BCT AGENDA  
January 21,2003  
1300-1600

**SUBJECT:** SEAD-16/17 Proposed Plan – Cleanup Goals (CUGs) for PAHs and metals and Cost/Volume Estimates

**Seneca Army Depot  
Ash Landfill  
Proposed Remedial Action Plan**

KEY PLAN	
Study Area	
<b>PARSONS</b> <b>PARSONS ENGINEERING SCIENCE, INC.</b>	
SENECA ARMY DEPOT ACTIVITY ASH LANDFILL PROPOSED REMEDIAL ACTION PLAN (PRAP)	
FIGURE 3 LOCATION OF FARMHOUSE AND TOTAL CHLORINATED ETHENES PLUME	
JOB NUMBER: 736677-01001	DATE: JULY 2001

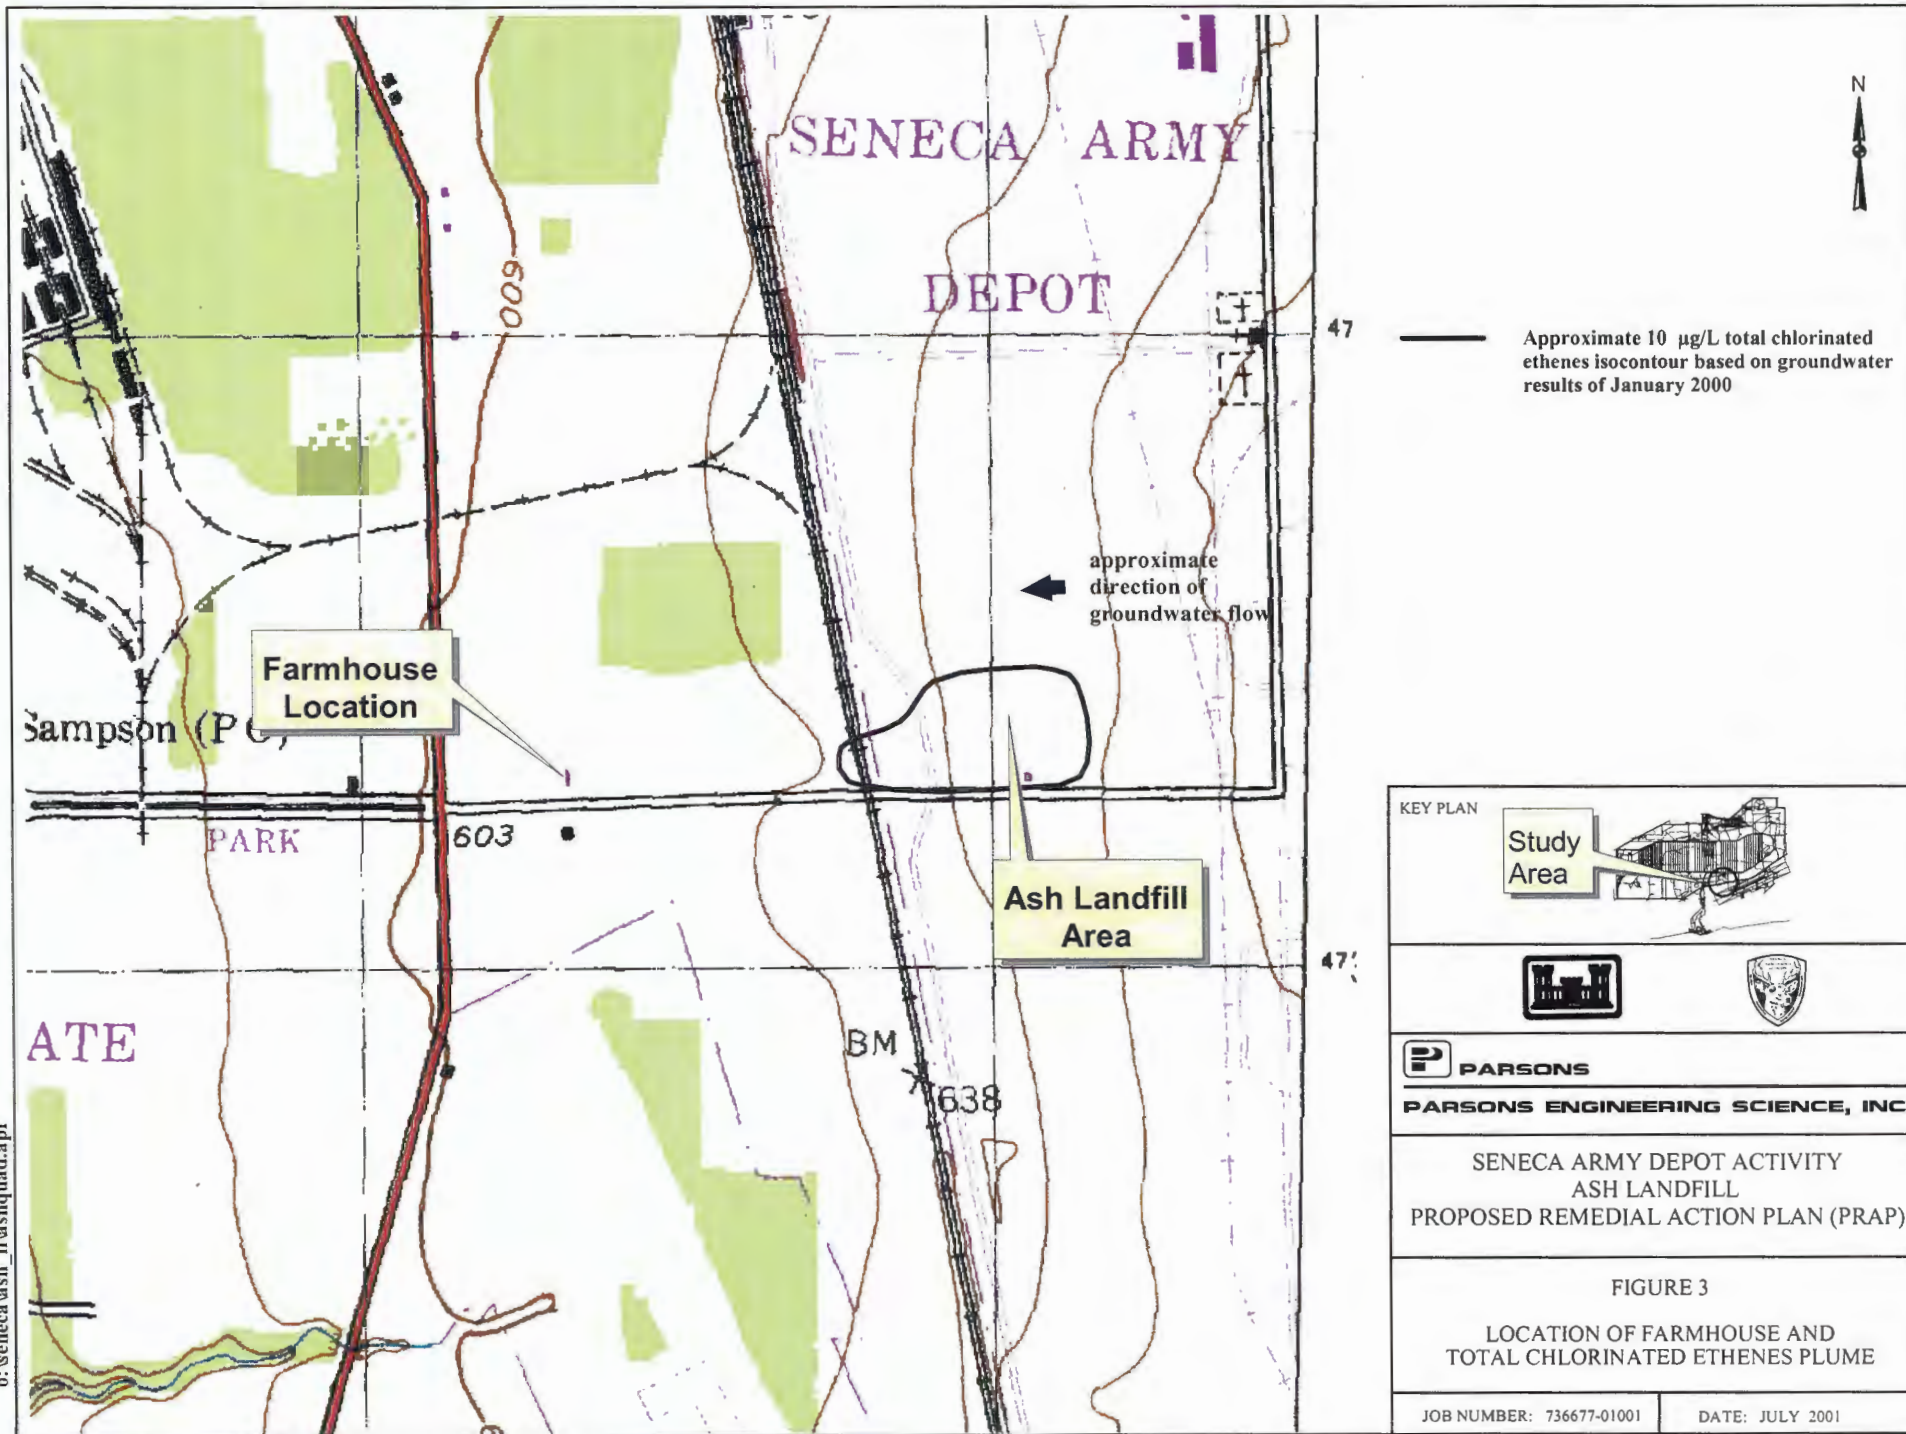
**Comment 15:** Although the Army has addressed the need for off-site groundwater monitoring using the sentinel well adjacent to the landfill, the Army has not rescinded it’s assumption that no future residential use of the land adjacent to the landfill is planned. The Army has no control over the future use of that land and should not infer that it knows what the property owner’s future intentions are.

**Response No. 2:** Agreed. The location of the farmhouse relative to the Ash Landfill and the groundwater plume is shown on new Figure 3. Figures 3 through 5 have been renamed as Figures 4 through 6.

**Response 1:** Agreed. The figure (Figure 3) was included in the June 2001 Final Proposed Plan; however, it was inadvertently left out of the July 2002 version. The figure has been added. A sentence has been added to the Groundwater section of the Remedial Investigation Summary that states, "The location of the farmhouse is provided on Figure 3".

FIGURE 2-10  
 CASE 3 REMEDIAL ACTION OBJECTIVE  
 SURFACE SOIL

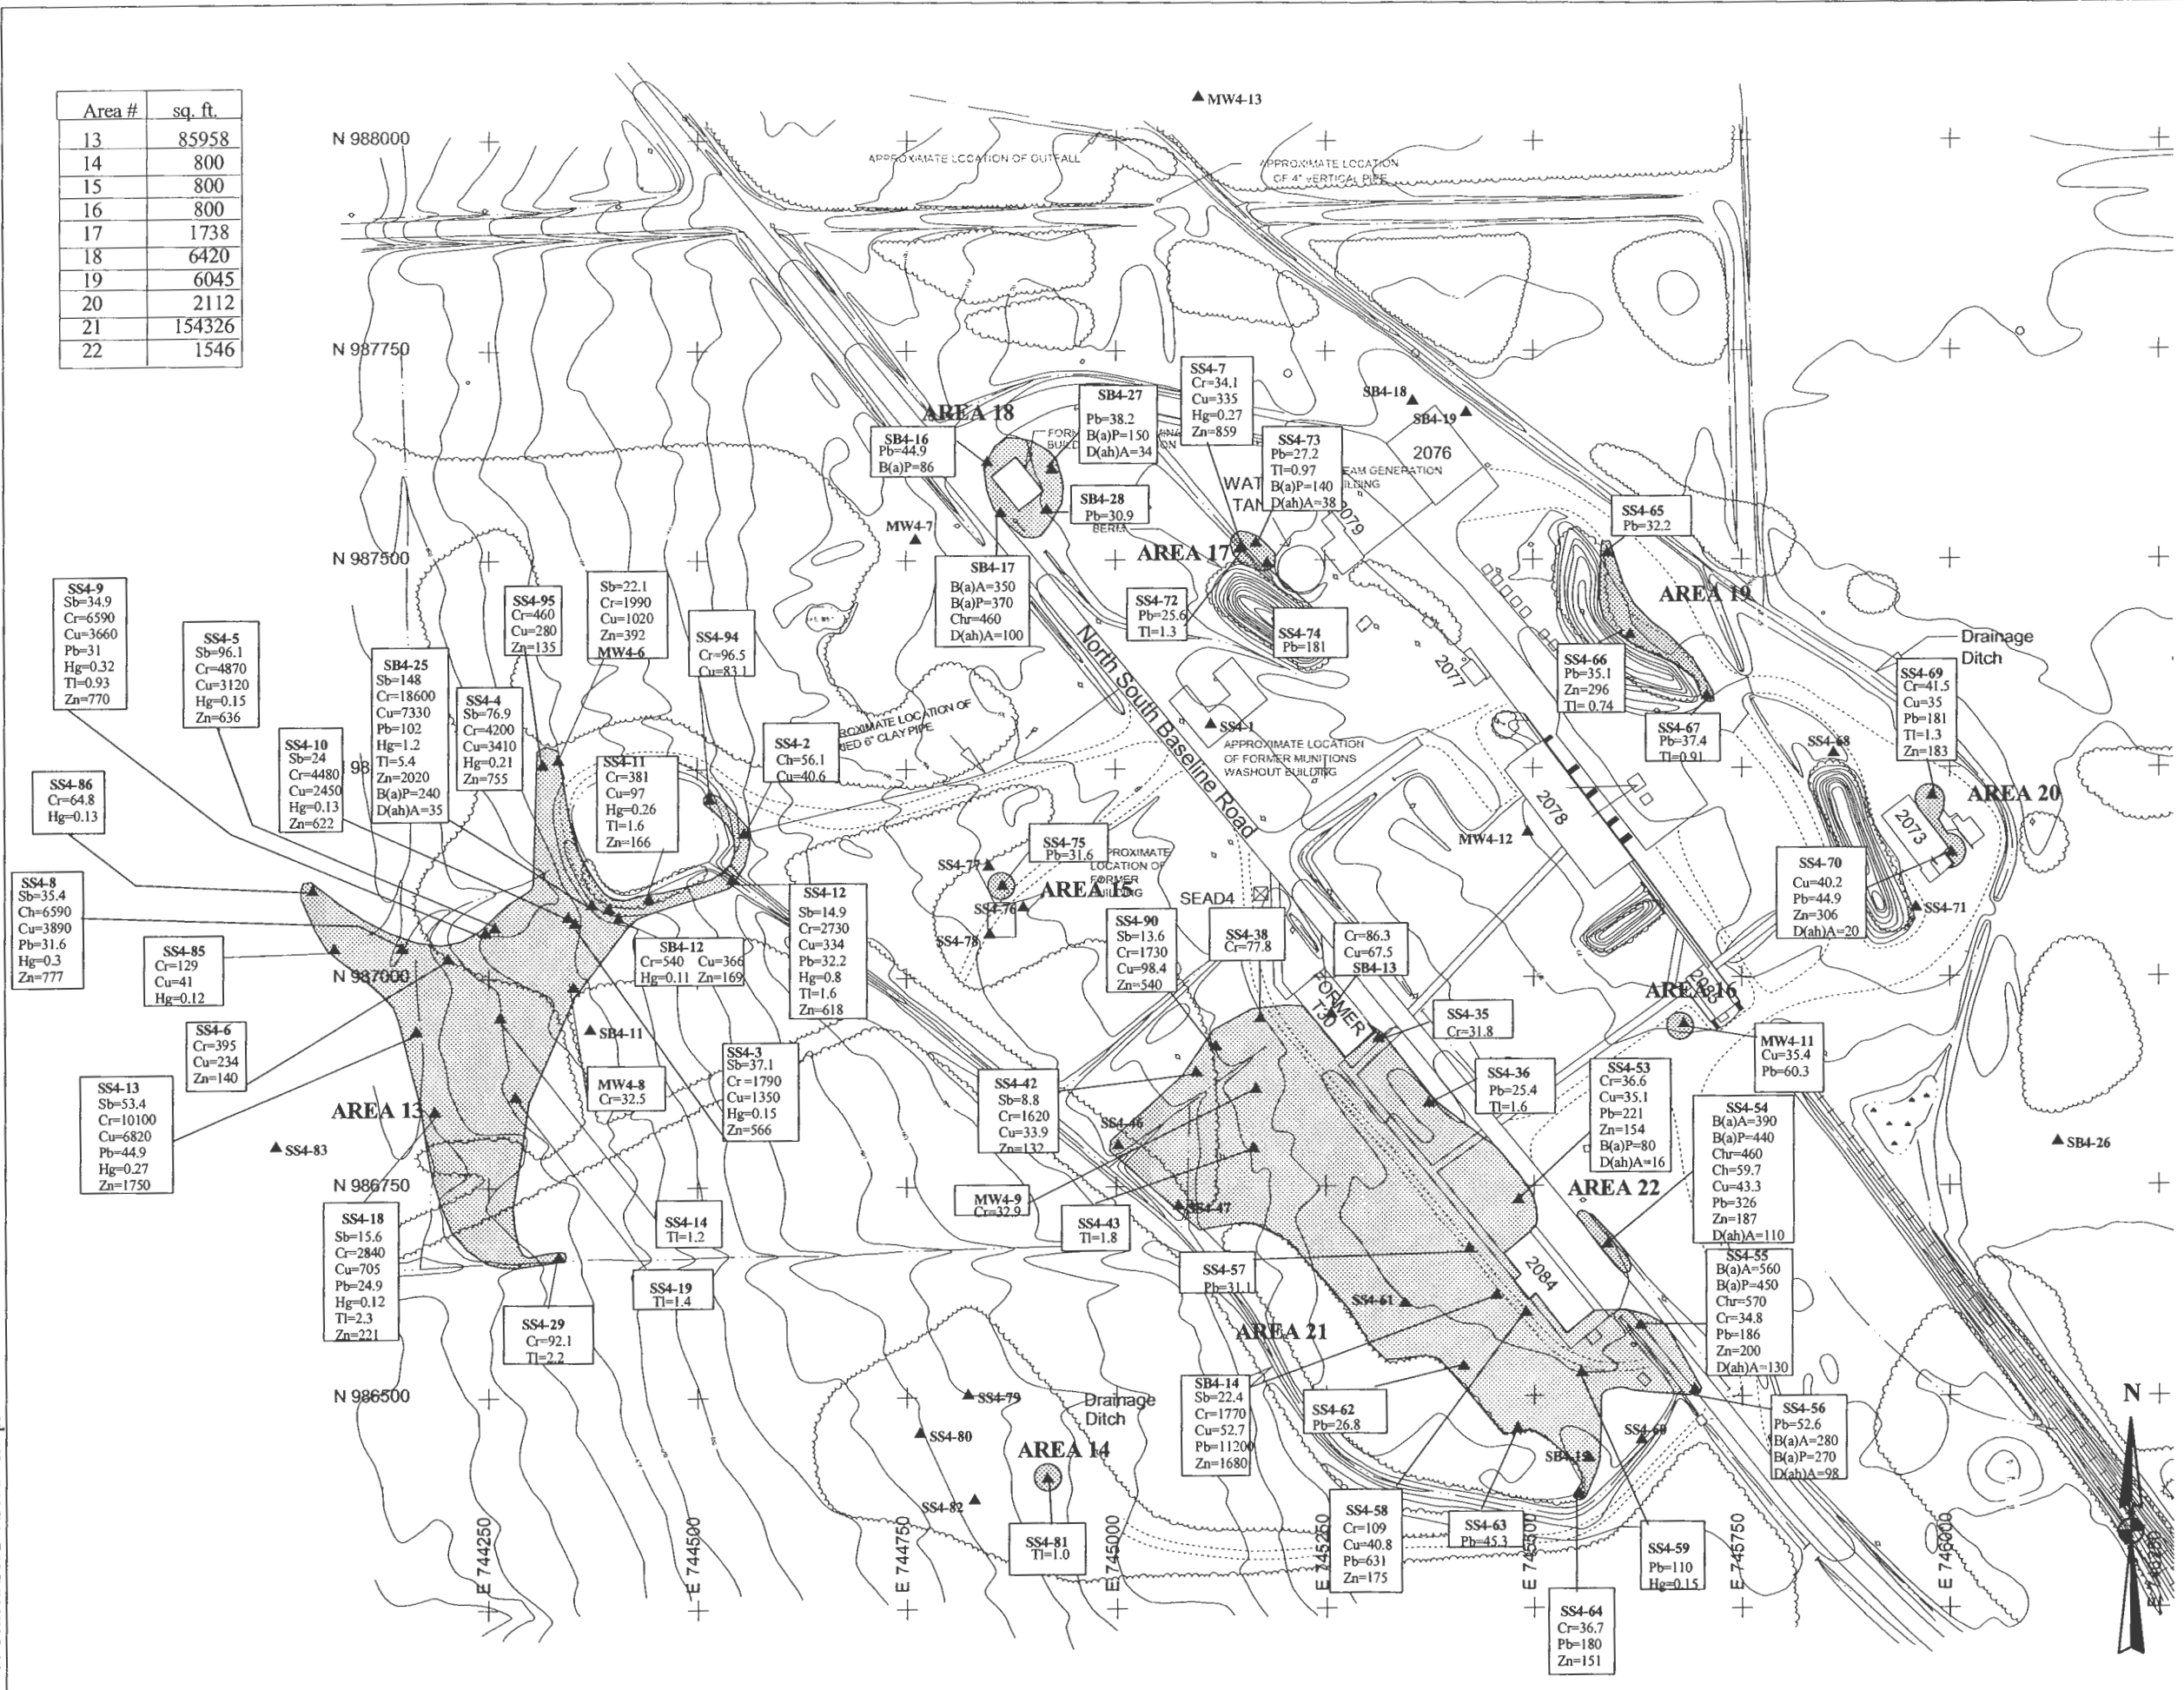
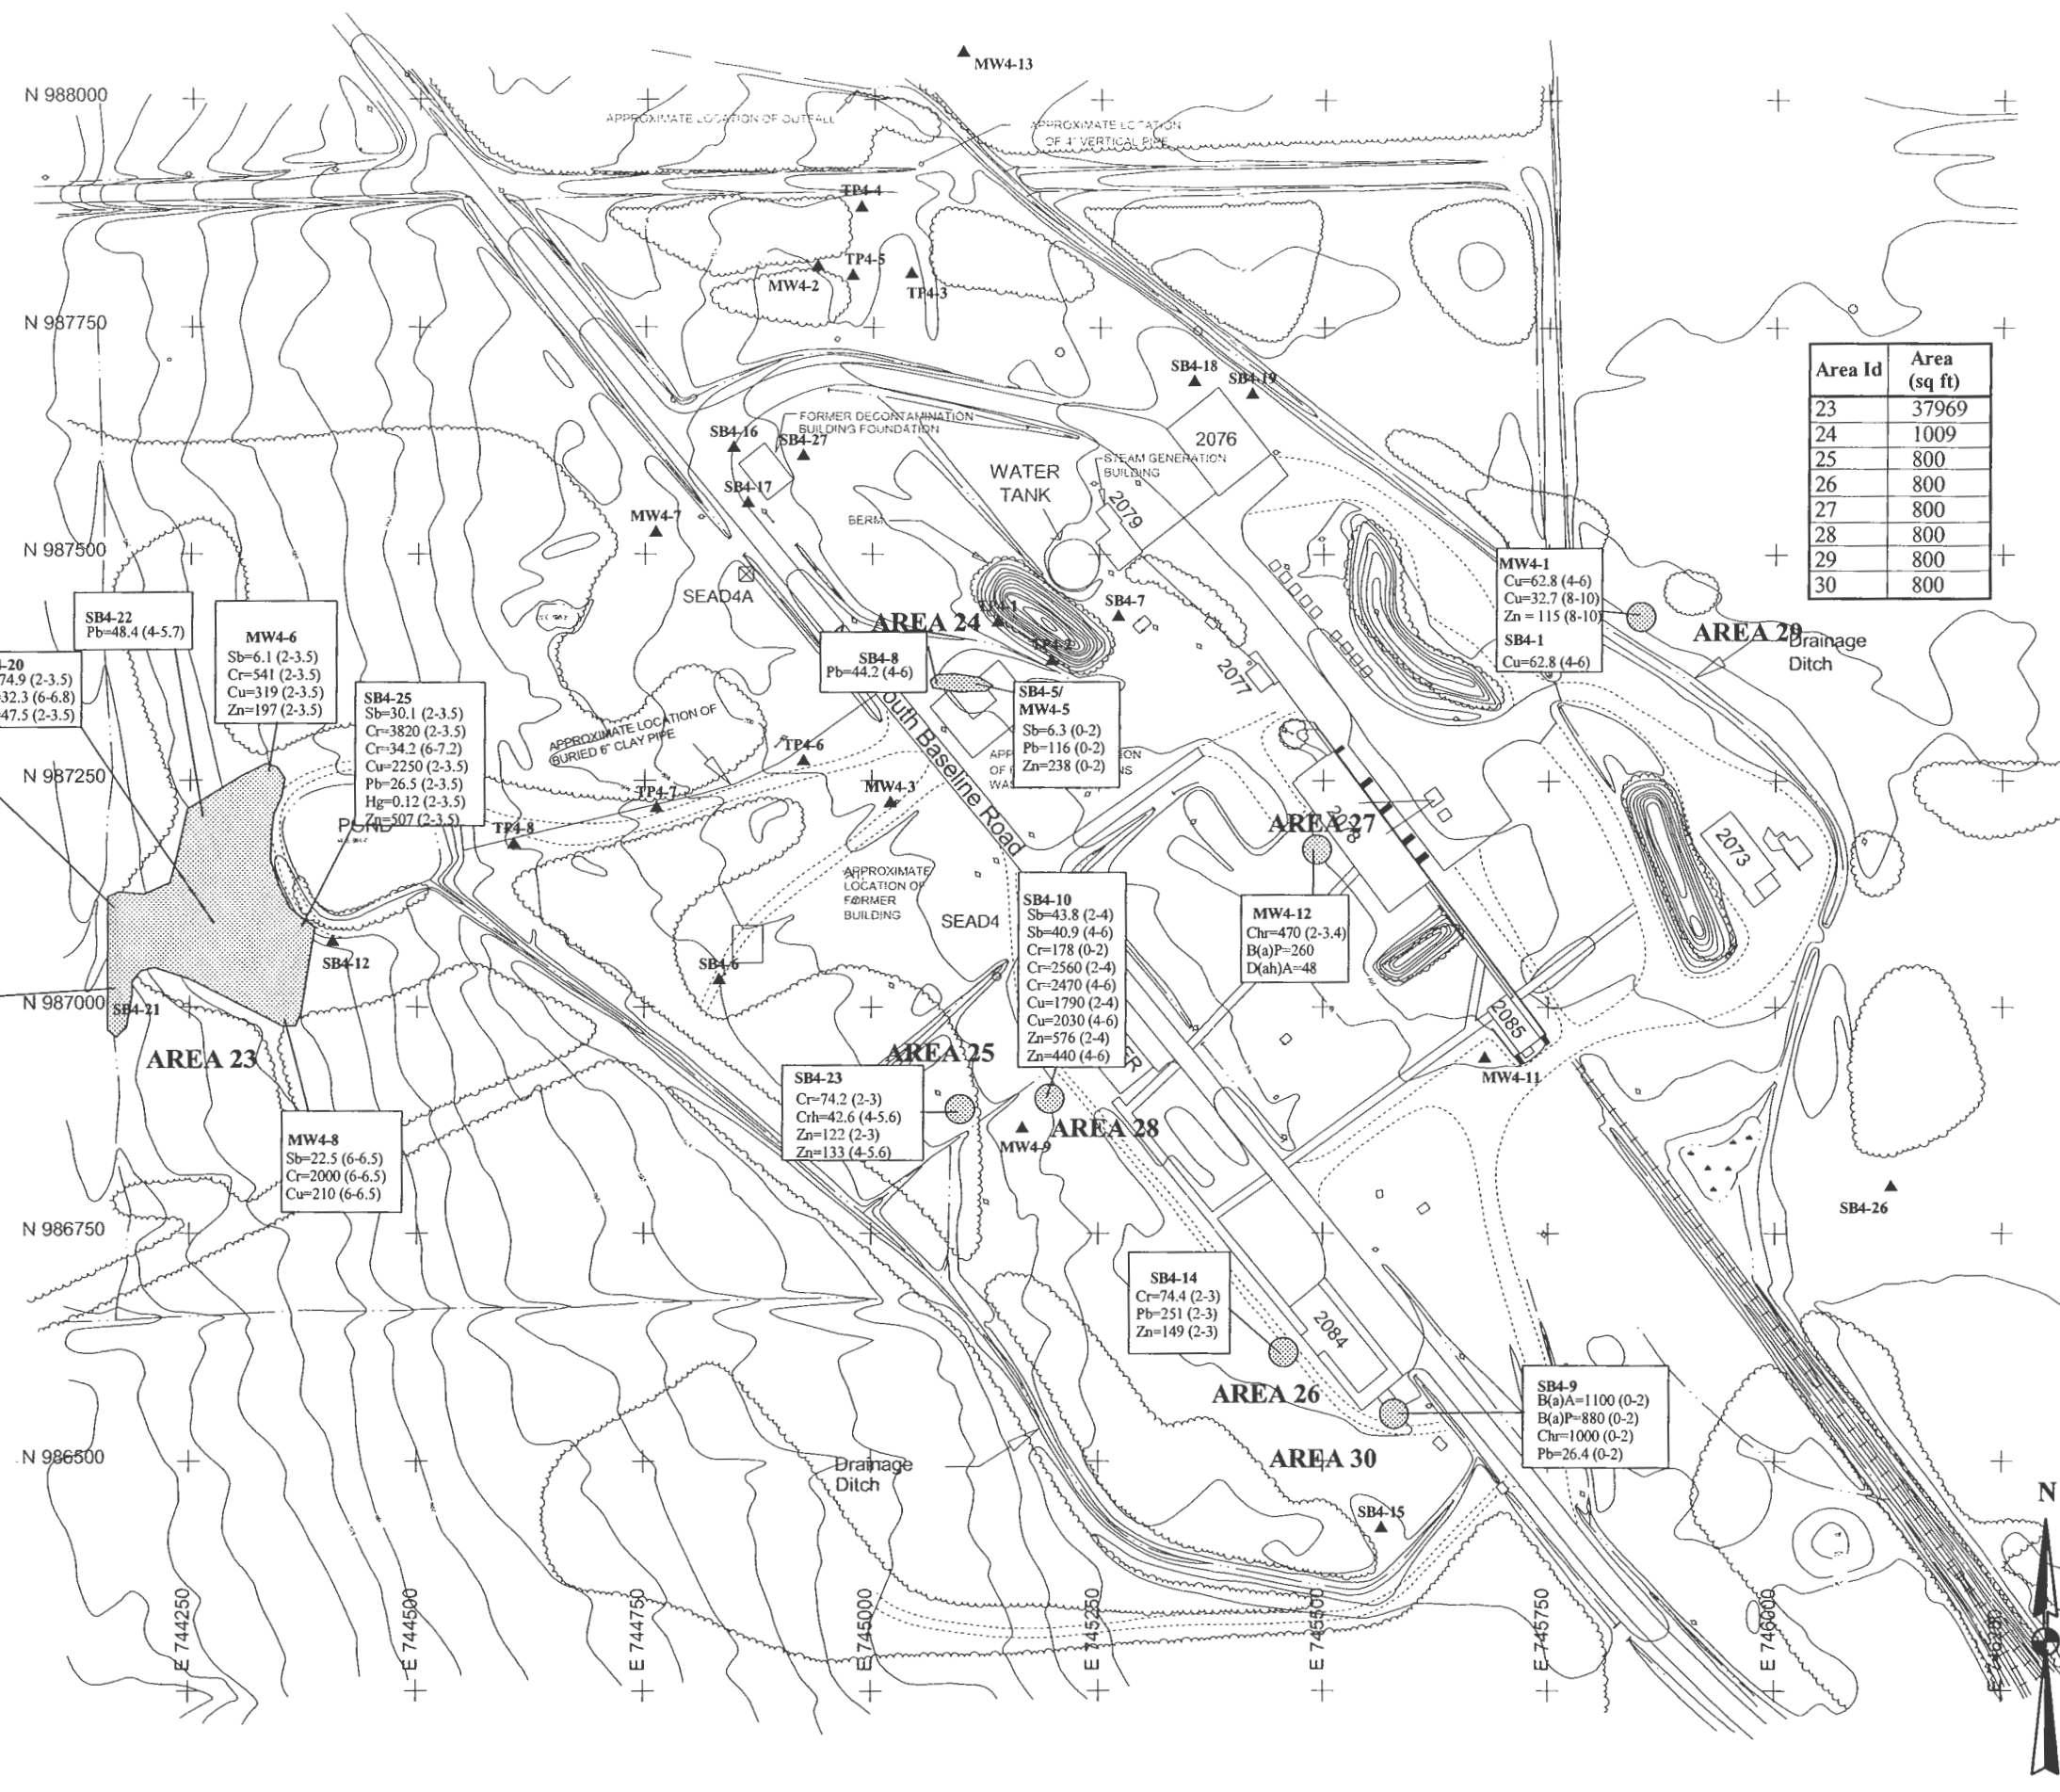
**Comment 12:** Figures 2-10 through 2-12: The tables in the legend of each figure are difficult to read. Please make them legible.
